PROJECT NAME:
BERKIN PROPERTY
99 Byram Ridge Road
Armonk, New York 10504
SBL: 101.01-1-13

We are pleased to submit a .pdf file of the following plans and documents in support of the application on behalf of Jackie and Brian Berkin for Site Development Plan Approval for a new residence on the property located at 99 Byram Ridge Road.

This letter responds to the comments in the memorandum from the Town Engineer dated February 26, 2024. Each comment is repeated below in italics, with the response appearing below the comment. As requested by the Planning Board at the meeting on 02/26/2024, we flagged on March 1, with orange pin flags, the corners of the proposed house on the property

Drawing Title:
Landscape Plan

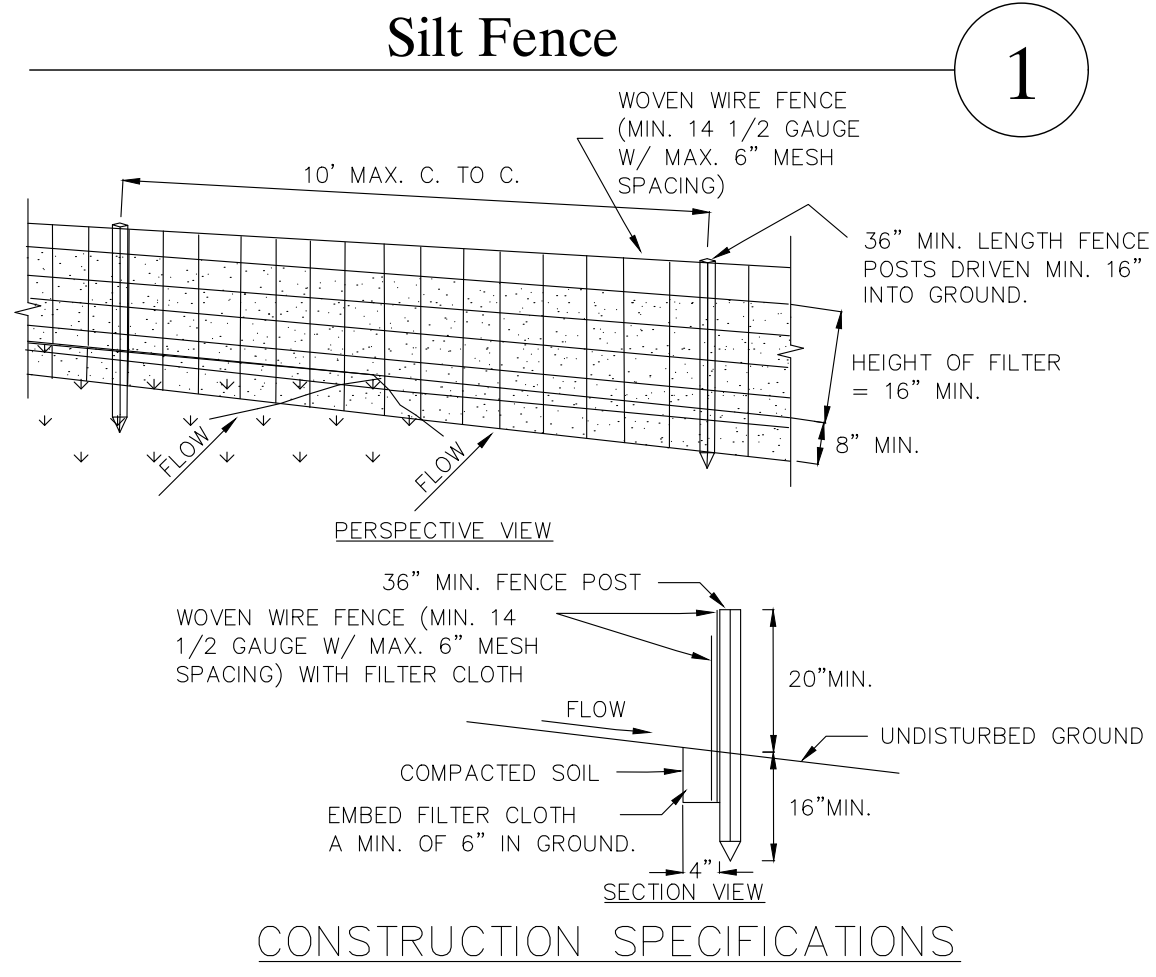
The project landscape plan should also address plantings in the vicinity of the retaining walls which can screen the walls from the neighboring residence and yard.

The landscape plan has been amended to propose the planting of an evergreen shrub and a clinging vine along the two walls proximate to the southern property line so as to provide screening from the neighboring residence and yard. Please refer to drawing C-104 for the landscape plan amendments.

TEMPORARY SEDIMENT BASIN BERM

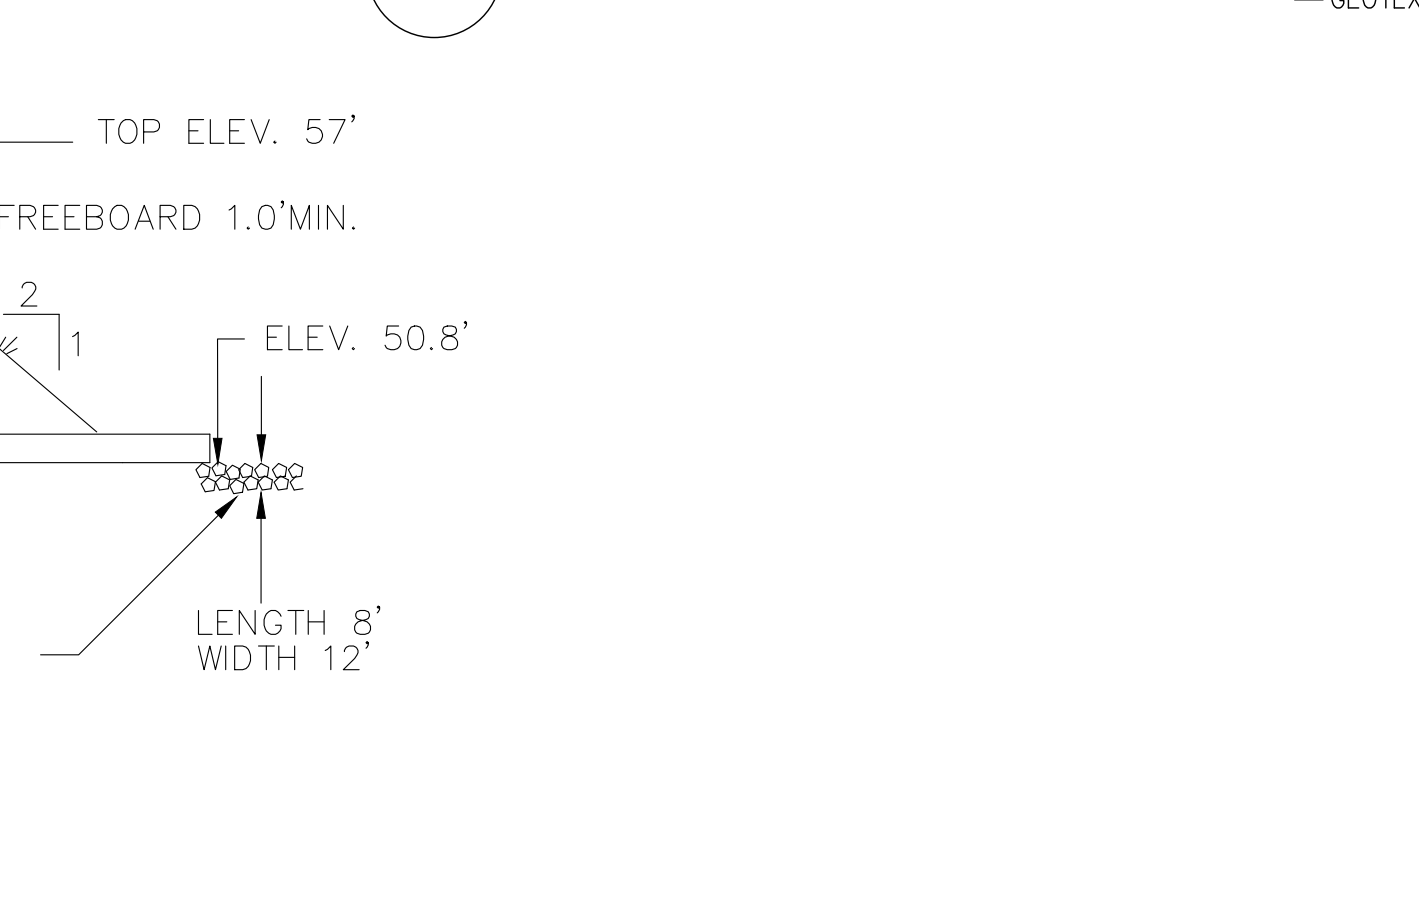
5. The applicant has prepared a SWPPP, which includes an erosion and sediment control plan to be implemented during construction. Erosion and sediment controls will include silt fencing, diversion swales, temporary sediment basin and stabilized construction entrance. The most significant aspect of the plan which provides the gradient protection to downstream properties is the temporary sediment basin. It is important, however, that the basin is properly sized to accommodate the drainage area tributary to the basin. The applicant therefore should provide sizing calculations for the temporary sediment basin. The basin should be designed to also accept the roof runoff from the proposed residence while under construction and prior to the gutter being installed and connected to the stormwater

mitigation system. Please provide a detail of the temporary sediment basin and its outlet controls.

Response: In accordance with the 2016 New York State Standards and Specifications for Erosion and Sediment Control, the sediment storage zone is to provide 1,000 cubic feet of sediment storage per disturbed acre. Given that the drainage area to the temporary sediment basin is calculated to be 1.043 acres (45,468 s.f.), the sediment storage zone is to be at least 1,044 cubic feet. In addition, the volume of the dewatering zone is to be 3,600 cubic feet per acre, or (1.043 acre x 3600 c.f./acre) 3758 cubic feet, for a total of 4,801 cubic feet required.

The proposed temporary sediment basin will provide a total of 5,077 cubic feet of storage, thus meeting the requirement of the Standards.
